**Smithfield City**  
**Central Park Production Well Pump and Motor Procurement**

**ADDENDUM NO. 1**

Date: March 16, 2022

1 WELL SECTION  
SCALE: N.T.S.

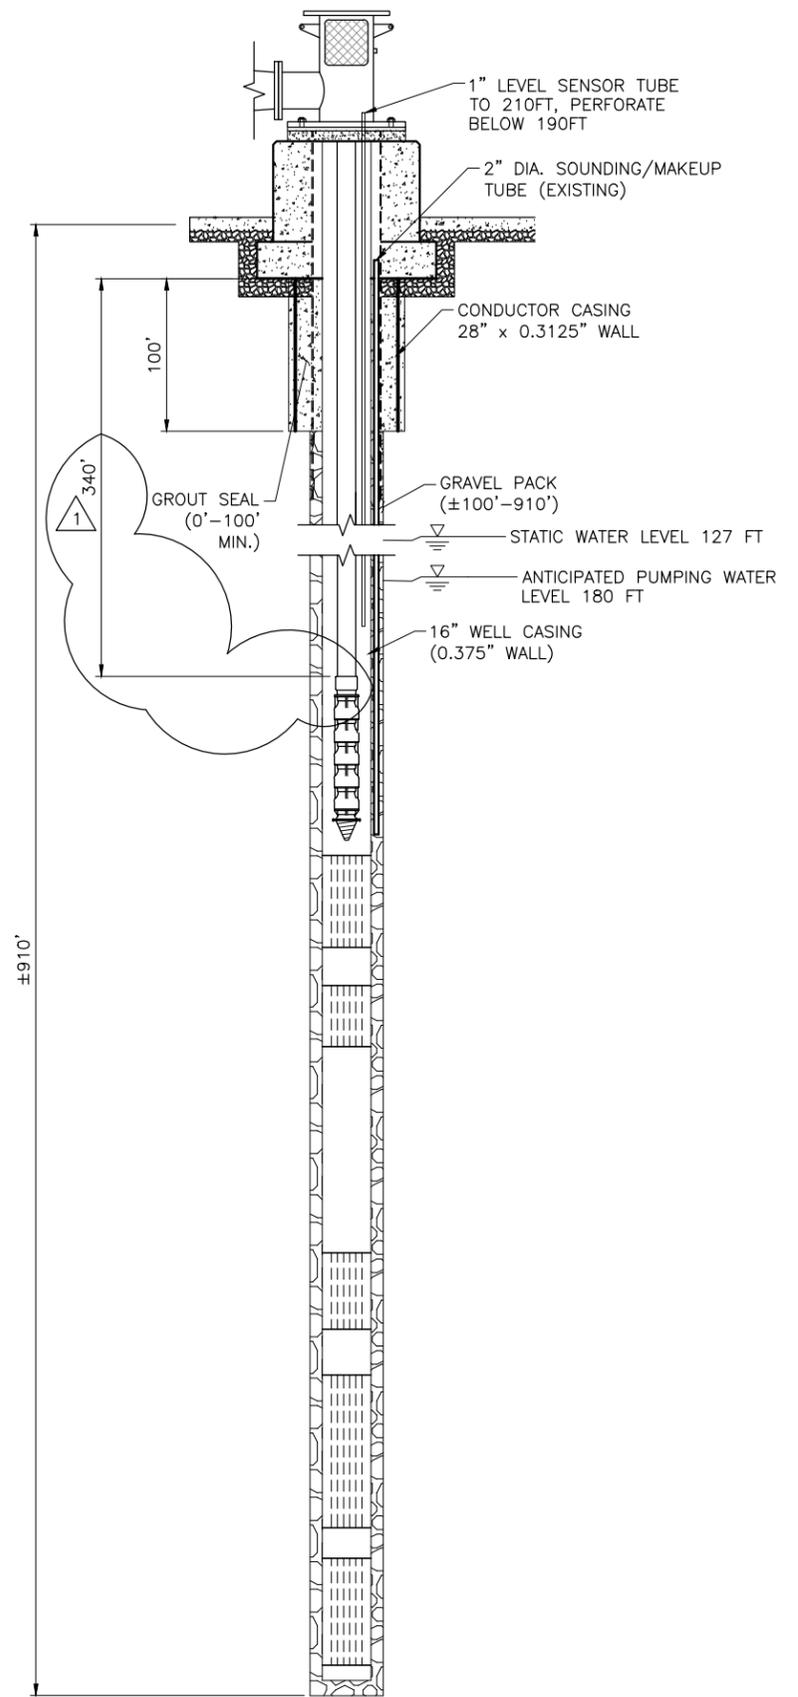
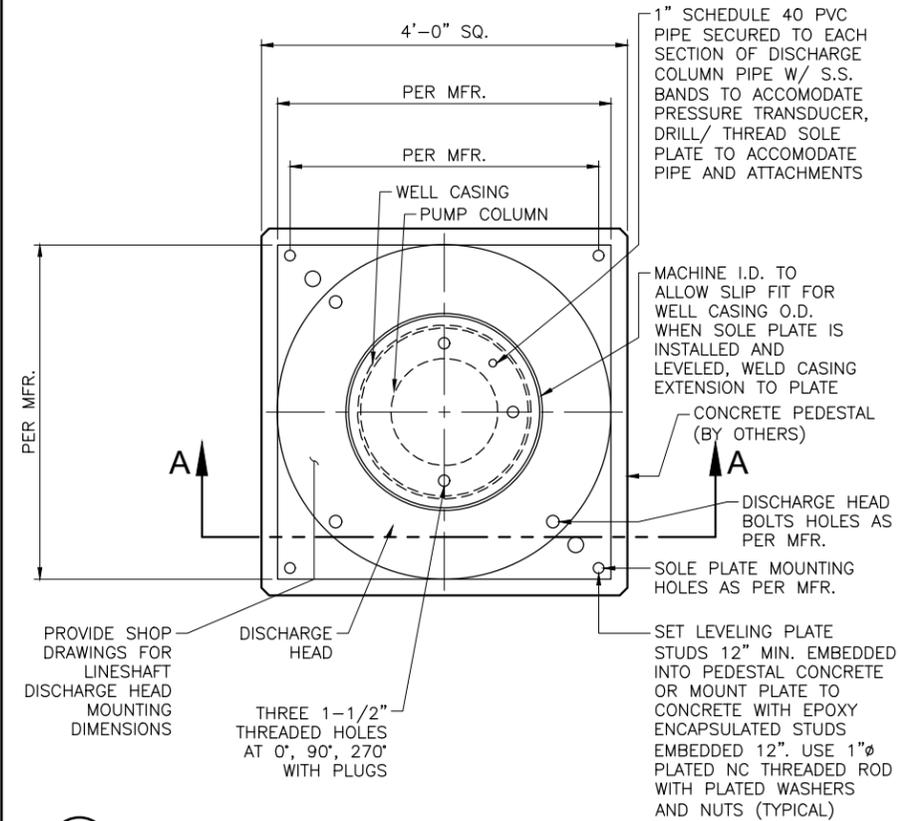
**Sheet 1**

Replace original Sheet 1 with revised Sheet 1 attached. The following modifications were made:

- Column depth dimension has been changed.

NO.	REVISION	DATE	BY	DATE
1	PUMP DEPTH	3/16/22
